12/04/15	GENERAL REVISIONS	1	MOD	KC	PJD
10/21/15	ISSUED FOR CONSTRUCTION	0	IDE	KC	PJD
DATE	REVISIONS AND RECORD OF ISSUE	NO.	BY	OK	APP.
50.3100	Structural Drawings				
SAVED: K0249353, 8/13/2015 2:16:08 PM					
PROJECT NO. 182262					
SHEET OF					
DESIGNED: WDB					
DETAILED: MAK					
CHECKED: KC					
APPROVED: PJD					
DATE: 10/21/15					
IF THIS BAR DOES NOT MEASURE 1" THEN DRAWING IS NOT TO FULL SCALE					
PROJECT NO. 182262					
S-20-101					
SHEET OF

**BEDFORD REGIONAL WATER AUTHORITY**  
SMITH MOUNTAIN LAKE WTP &  
RAW WATER PUMP STATION / INTAKE

**STRUCTURAL**  
RAW WATER INTAKE PUMP STATION VAULT  
PLAN, SECTIONS AND DETAIL

**PIPE PENETRATION @ WALLS D**  
3/4" = 1'-0"

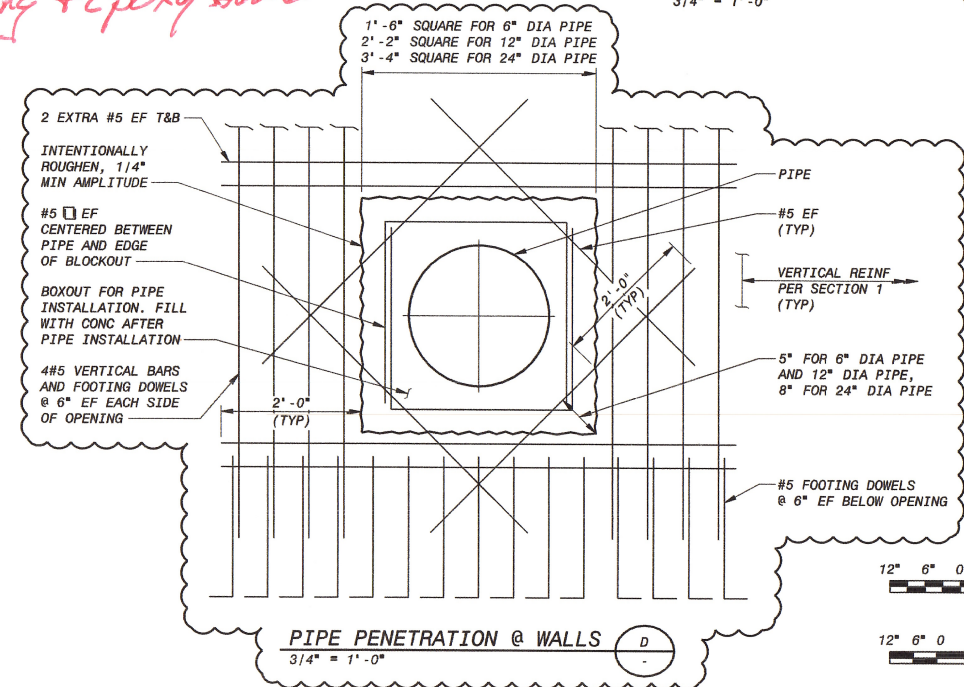
*Add Thickened Concrete  
Pump Can Collar w/ #5  
Reinforcing + Epoxy Dowel*
